# UNITED STATES PATENT AND TRADEMARK OFFICE

APPLICATION NO.	FILING DATE	FIRST NAMED INVENTOR	ATTORNEY DOCKET NO.	CONFIRMATION NO.
10/828,993	04/21/2004	Harold Alexis Huggins	HUGGINS 7	5503
47396	7590	10/18/2007		
HITT GAINES, PC LSI Corporation PO BOX 832570 RICHARDSON, TX 75083			EXAMINER LIE, ANGELA M	
			ART UNIT 2163	PAPER NUMBER
			NOTIFICATION DATE 10/18/2007	DELIVERY MODE ELECTRONIC

<b>Office Action Summary</b>	<b>Application No.</b> 10/828,993	<b>Applicant(s)</b> HUGGINS, HAROLD ALEXIS	
	<b>Examiner</b> Angela M. Lie	<b>Art Unit</b> 2163

3. **Claims 29, 35-37 and 40 are rejected under 35 U.S.C. 102(e) as being anticipated by Sridharan et al (US Patent No. 6525623).**

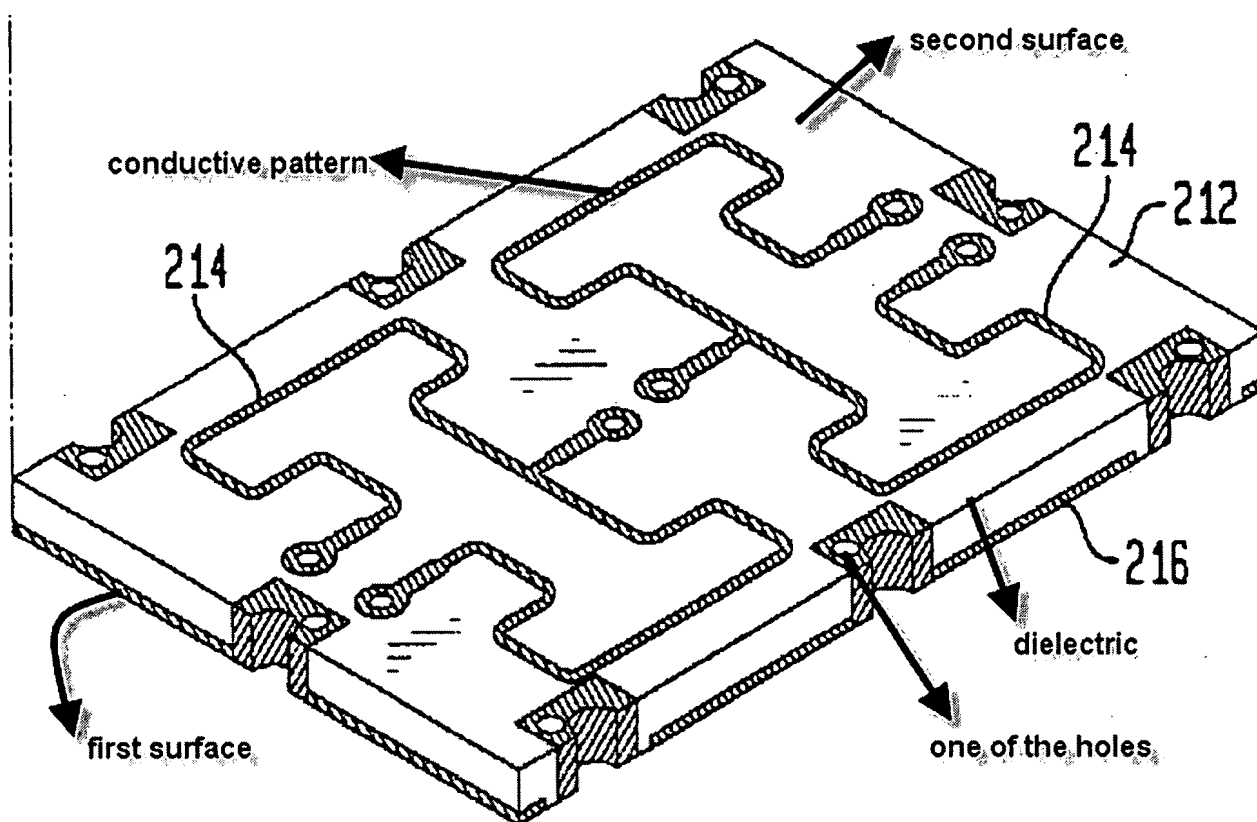
**As to claim 29,** Sridharan discloses a radio frequency (RF) component comprising: a dielectric layer (Figure 9, element 212) having opposing first (Figure 9, bottom side) and second major surface (as indicated in the figure below) being free from a semiconductor substrate, the dielectric layer (Figure 9, element 212) having a plurality of openings (as indicated in the figure below) between the first and second opposing major surfaces; and a patterned conductive (Figure 9, as indicated below) layer on the second major surface of the dielectric layer, wherein the plurality of openings are

arranged in a predetermined pattern along laterally opposing sides of the patterned conductive layer (as shown in figure below).

**As to claim 35**, Sridharan discloses the RF component wherein the plurality of openings are laterally adjacent portions of the patterned conductive layer with no openings extending through the patterned conductive layer (as shown in the figure above the holes adjacent to the edges (as indicated in the drawings above) are not extending through the patterned conductive layer.

**As to claim 36**, Sridharan discloses the RF component wherein each of the plurality of openings is cylindrically shaped (as shown in figure above).

**As to claim 37**, Srindharan discloses the RF component wherein there is substantially uniform spacing between the adjacent openings on each of the opposing sides of the patterned conductive layer (as shown in the figure above the spacing between holes is uniform).

8. With respect to the applicant's assertion on page 4, third paragraph alleging that "Sridharan does not teach a dielectric layer having opposing first and second major, the first surface being free from a semiconductor substrate", the examiner disagrees. As indicated in the rejection above, the figure shown above clearly illustrates dielectric layer having two surfaces with through holes, wherein first surface is free from a semiconductor.
